Changes in Rev C

FILE NAME Extender Top	FSCM NO	SHEET	SCALE 5 : 1
SIZE			
DRAWN 7-1-2015 I.C.E.C			
CHECK		Pick & Place Tool	
APPR.		FirePick Delta Modular Tool Tip	
ISSUED 12-1-2015 I.C.E.C			
REV C		DWG NO	
CONTRACT NO

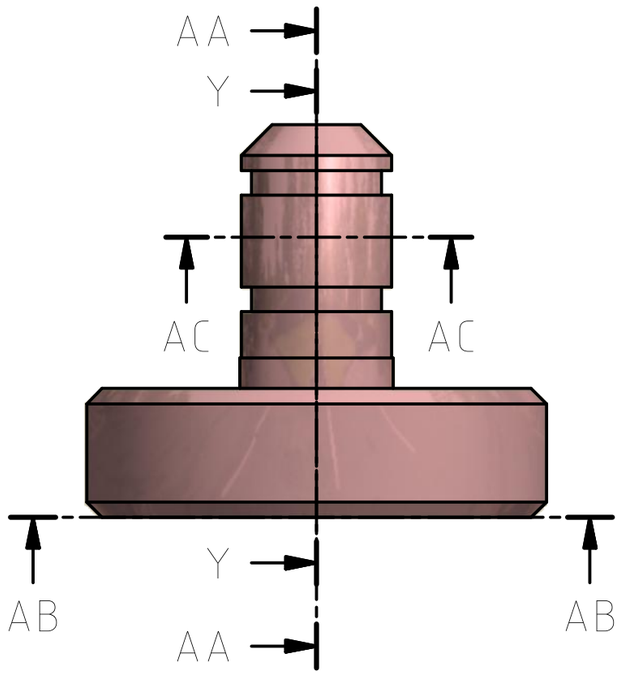
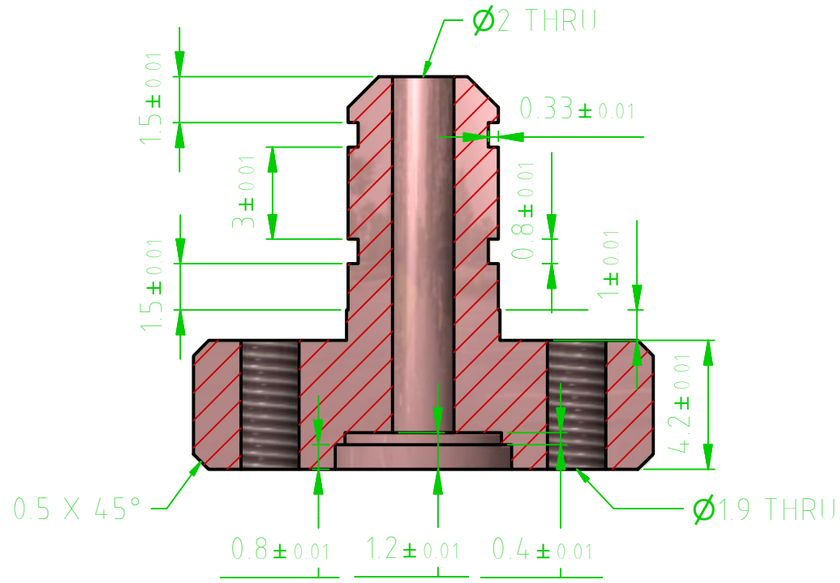
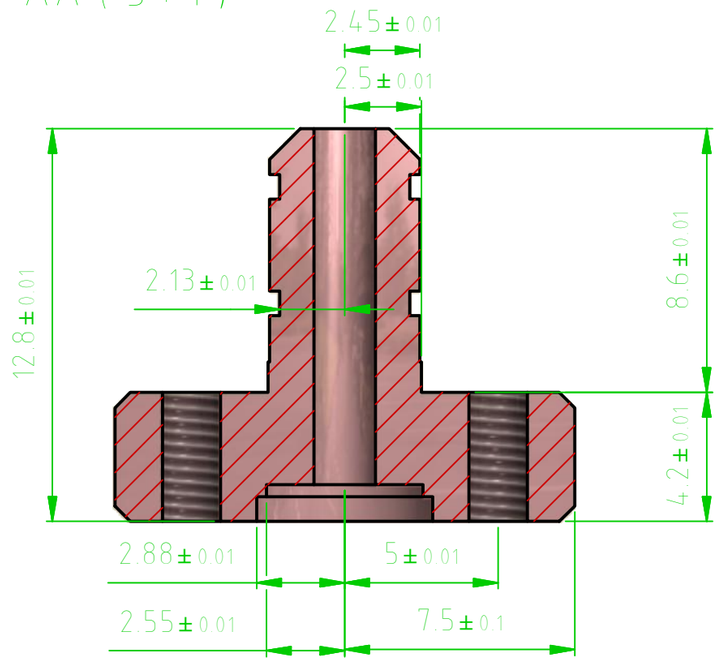
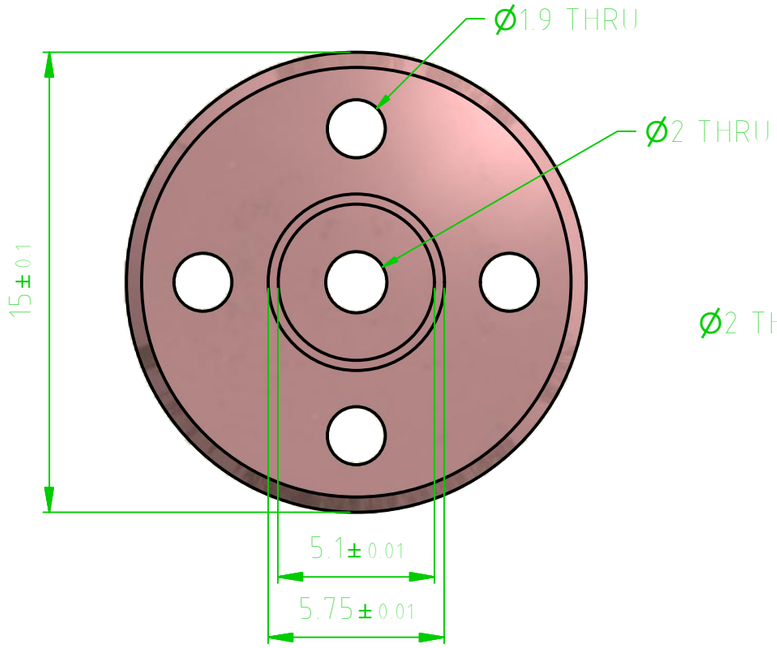
-Made piece a bit longer for bottom axial o-ring design

-Changed blind taped holes to tru hole for easy machining

- Reposition bottom grove for O-ring to axial position in design

- No overall length change, total length is 11.6mm
